PROPOSED CHANGE ORDER

PROJECT: Montgomery High School

PCO #: 25

DESCRIPTION OF THE PROPOSED CHANGE: Added Landscaping Project

L-106

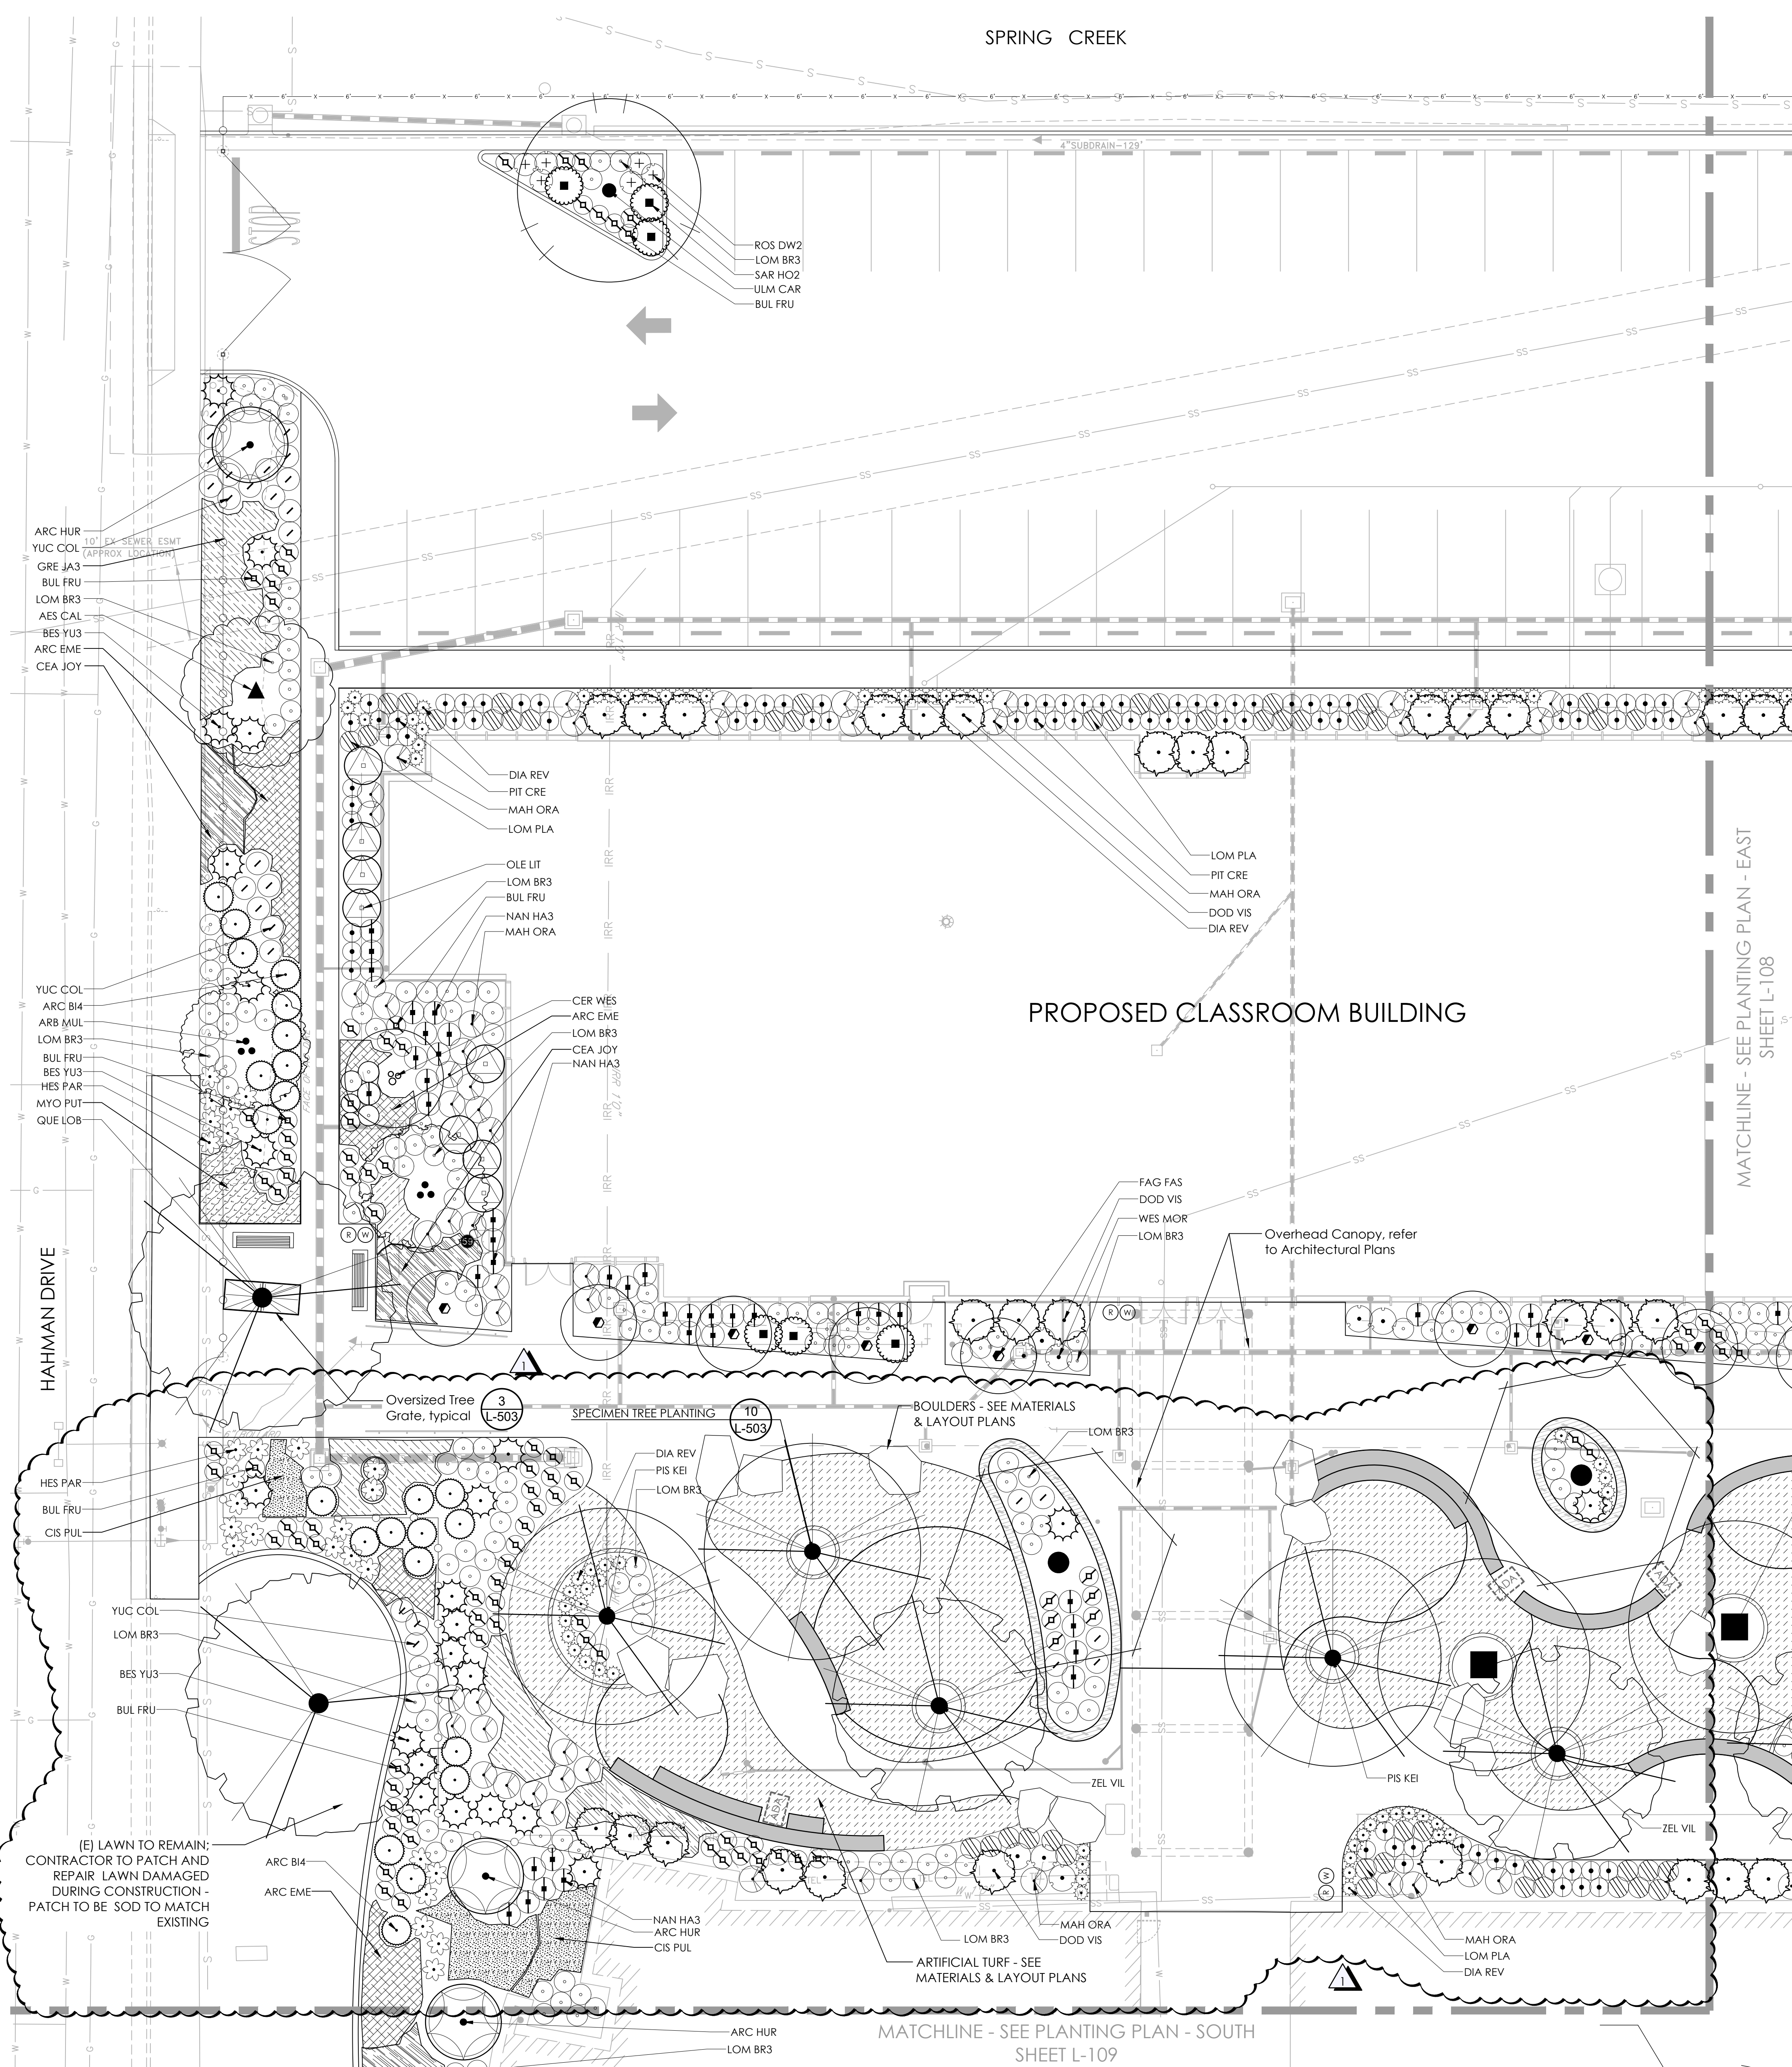
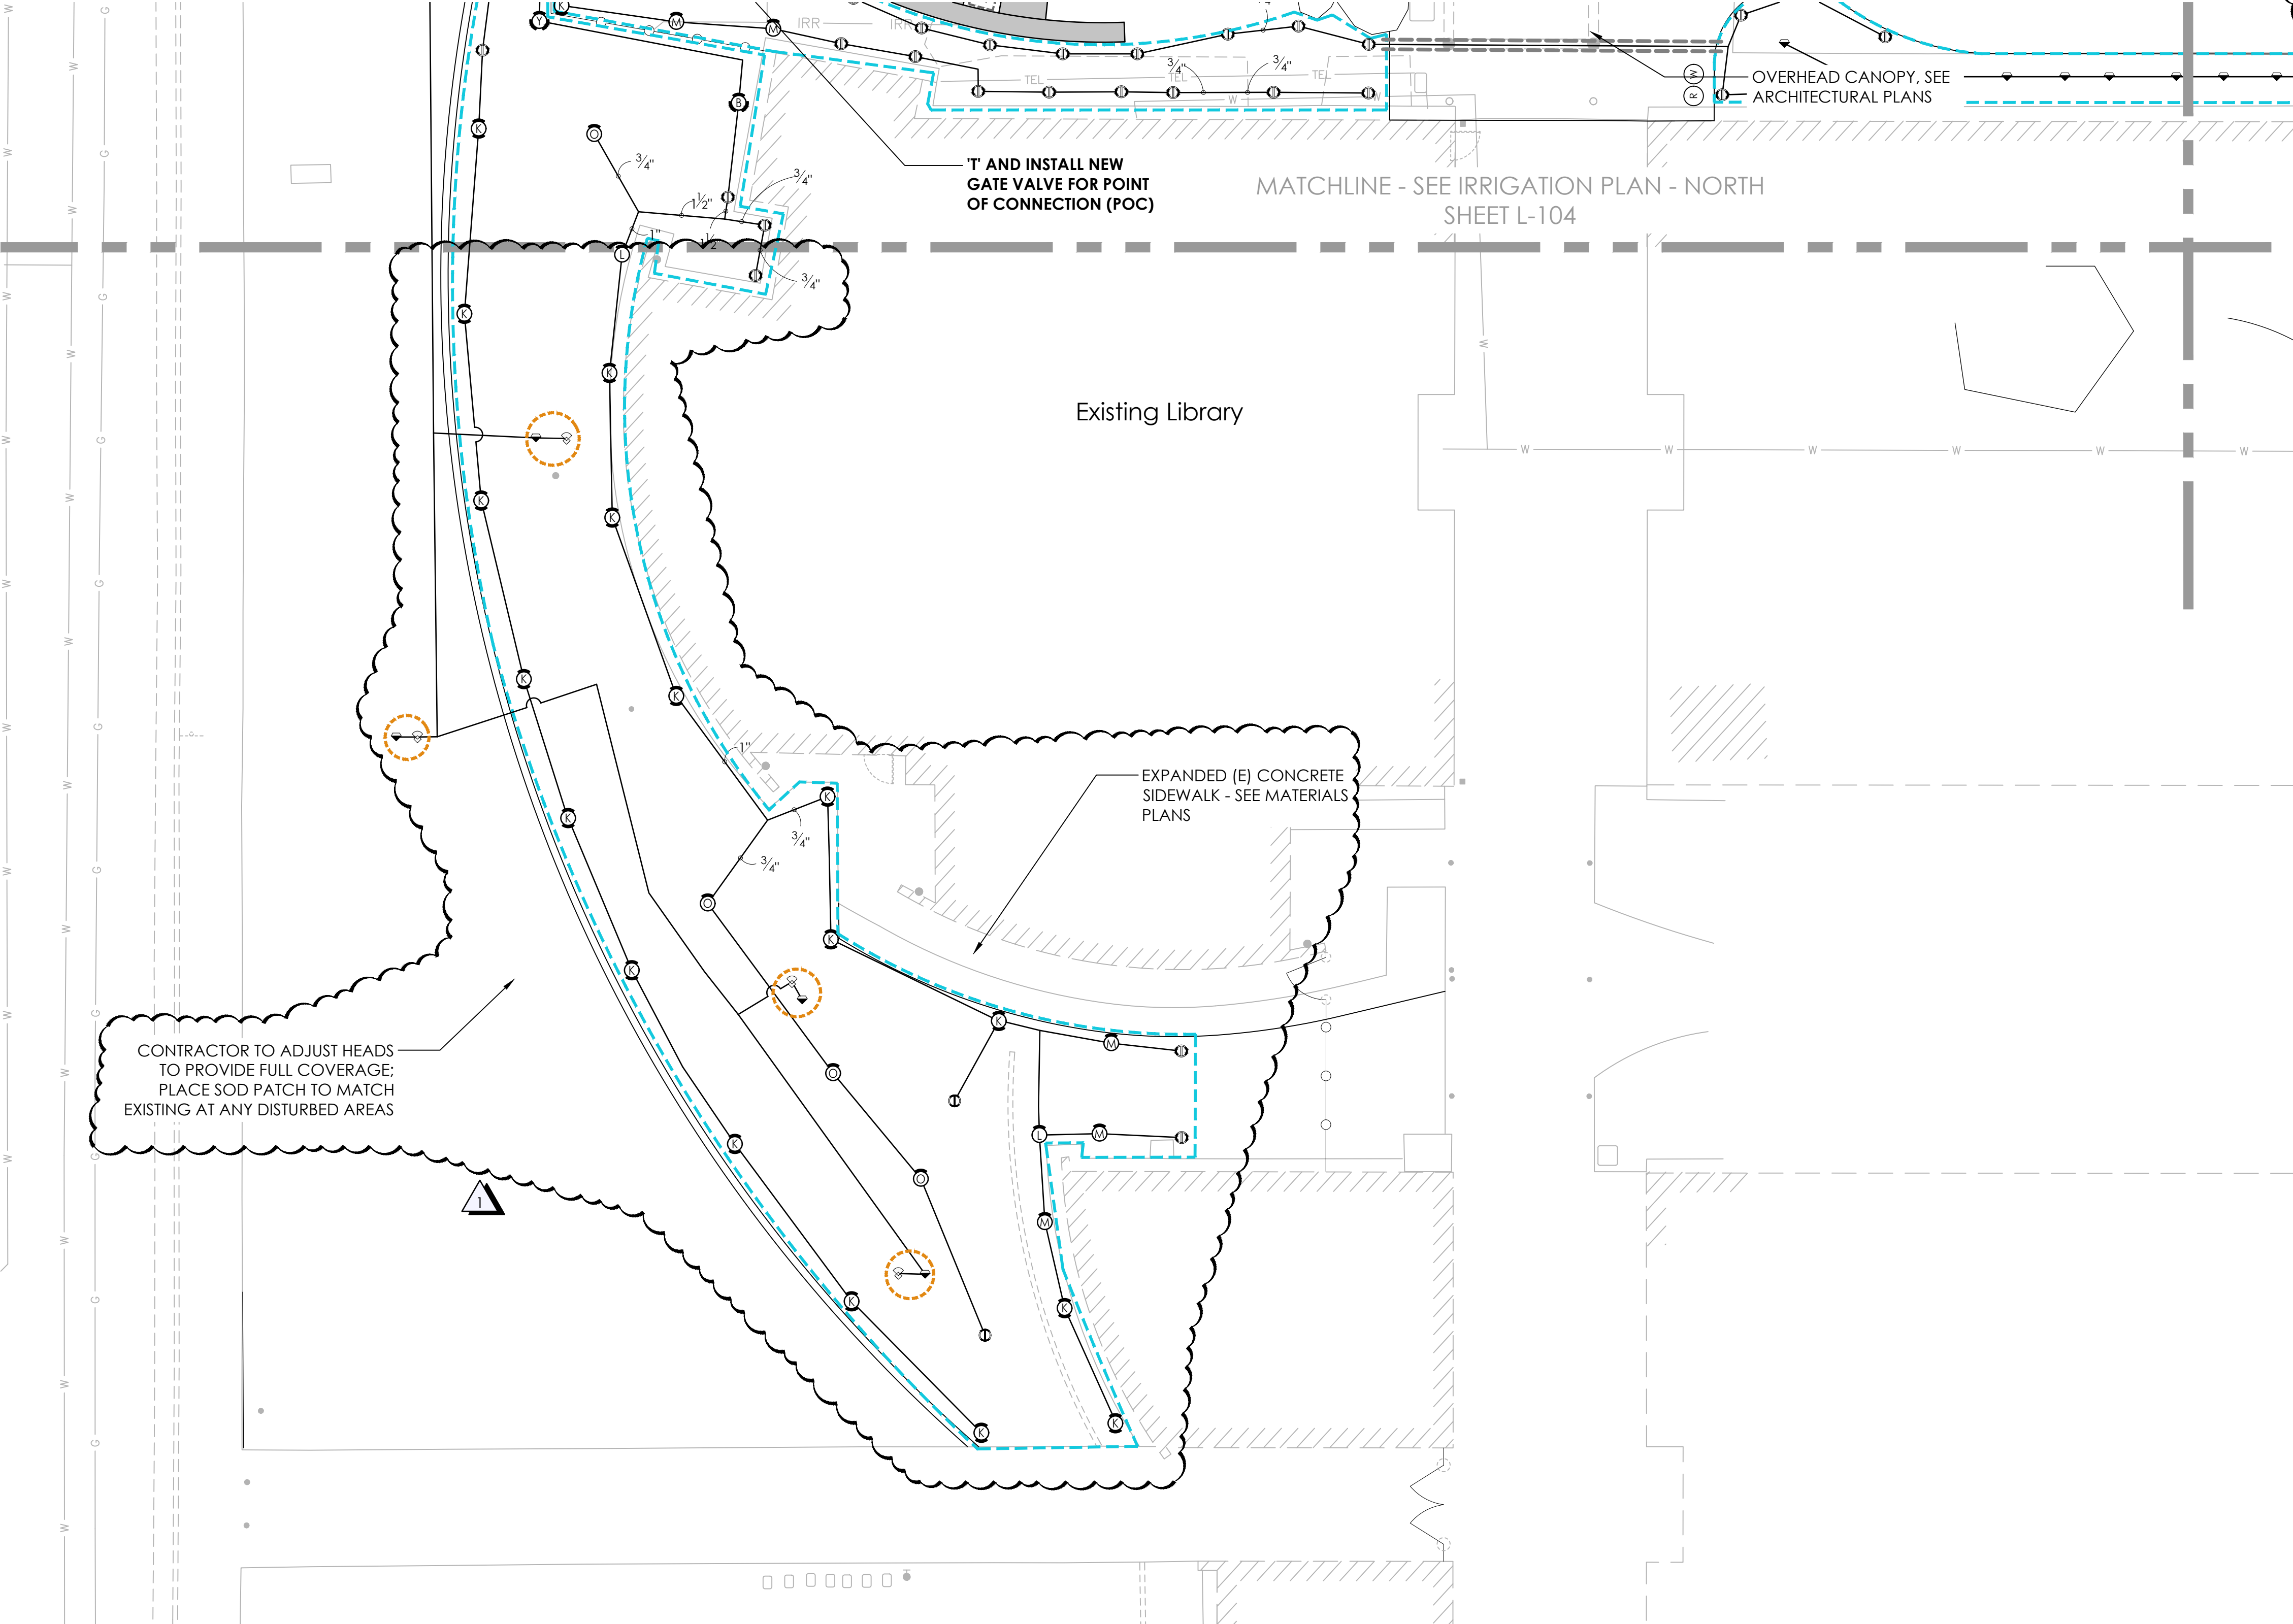
SHEET	CHANGE
L-106	Updated irrigation plan and welo calculations for area south of new classroom building and area south of existing library
L-107	Updated planting plan for area south of new classroom building
L-108	Updated planting plan for area south of new classroom building
L-109	Updated planting plan for area west and south of existing library building
L-503	Added specimen tree planting detail
L-504	New sheet added for planting and fencing details
L-505	New sheet added for site details including gates
L-506	New sheet added for site details including gates

7 ARTIFICIAL TURF MOUND

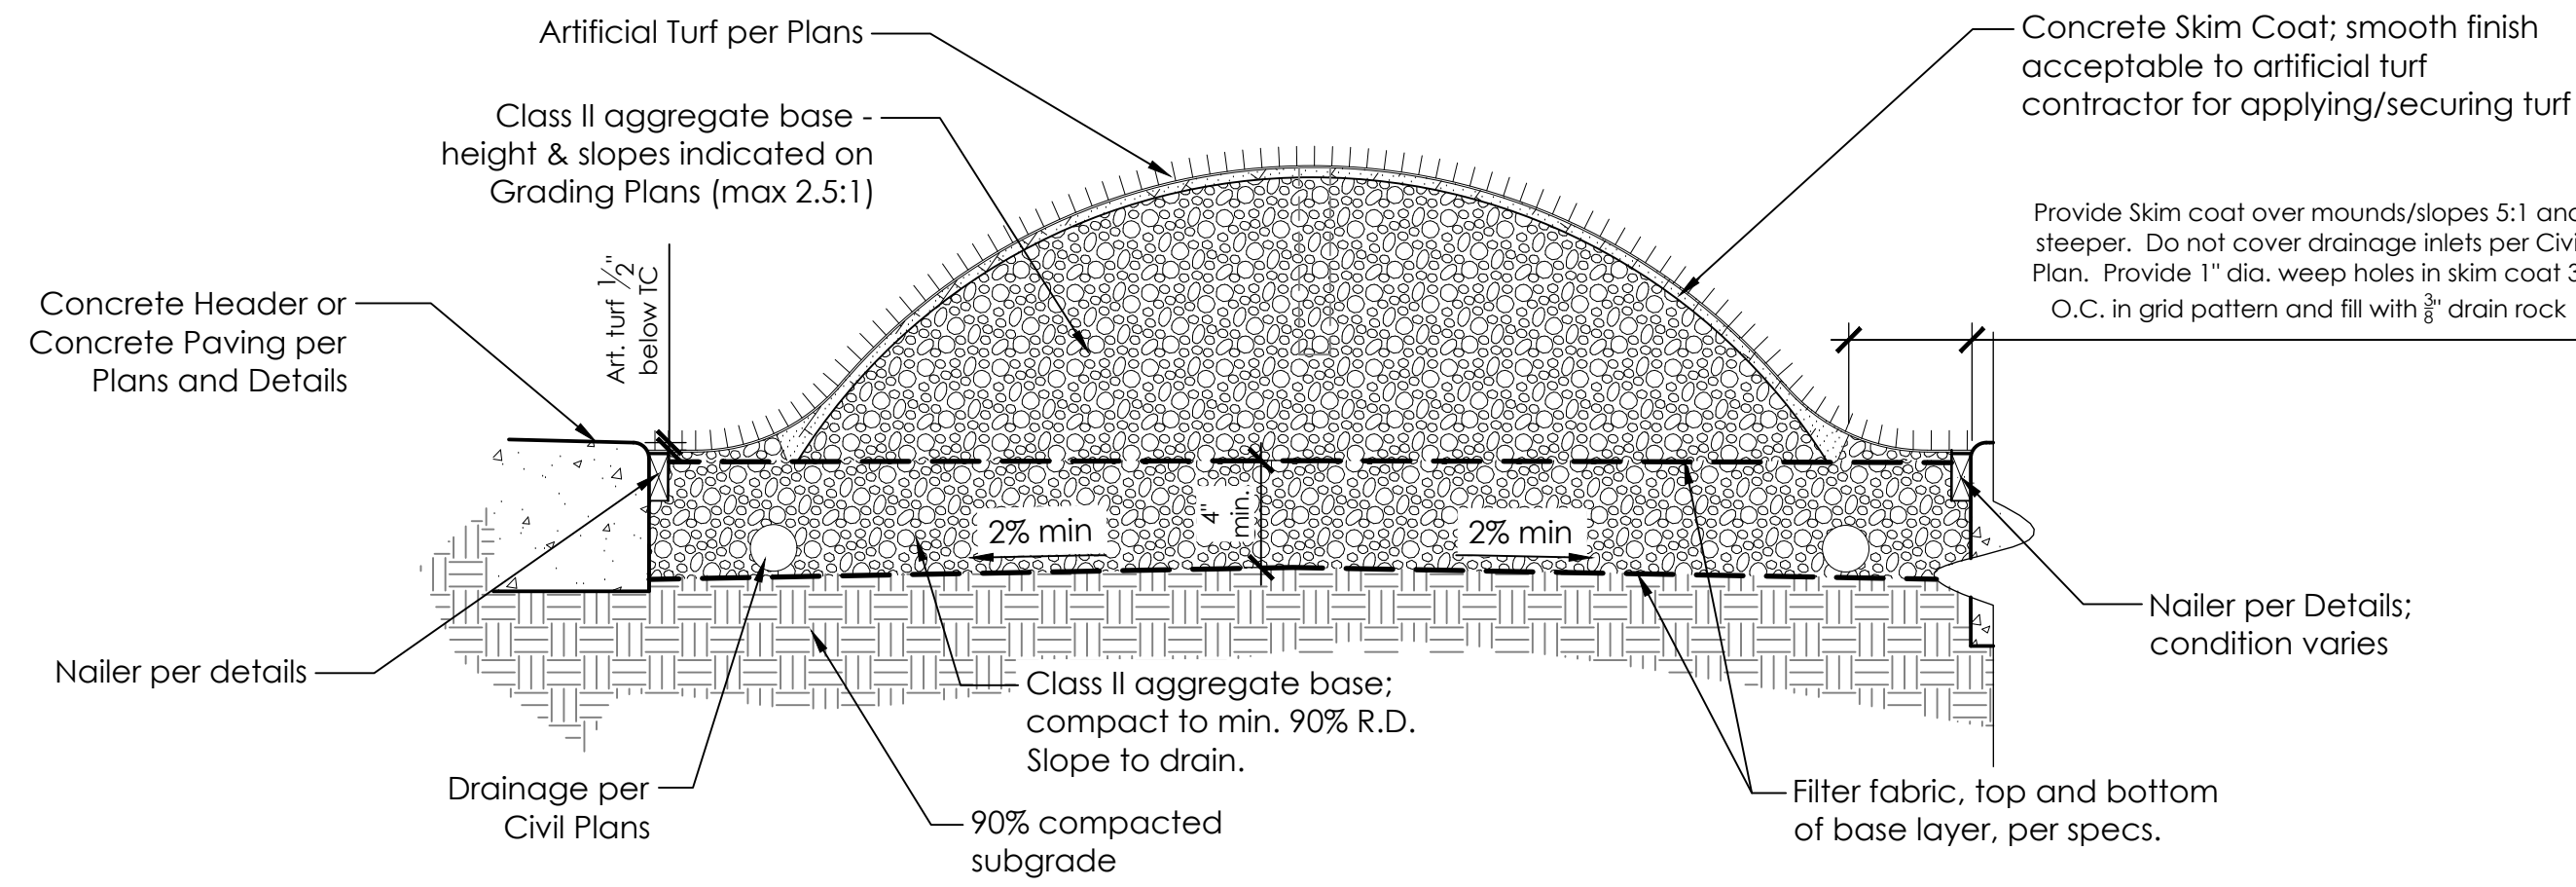
Revised CCD 006 – Landscape Changes for Irrigation, Planting, Boulders and Synthetic Turf. All grading by others, deleting detail #7/L5.04 (skim coat and mounds and weep holes). Based on reducing size of boulders to a maximum of 5'W x 4'L x 3'H (same quantity and locations). Changing manufacturer of turf to Heavenly Greens in lieu of Forever Lawn

1. Same terms and conditions as subcontract.
2. All grading, subgrade prep and ABII by others. Planting areas to be received at -3" from finished grade to allow for amendment and mulch. Synthetic turf areas to be received at -1" from finished grade to allow for fines.
3. Based on using Heavenly Green 'Coronado' or 'HG Bounce' turf in lieu of specified Forever Lawn turf.
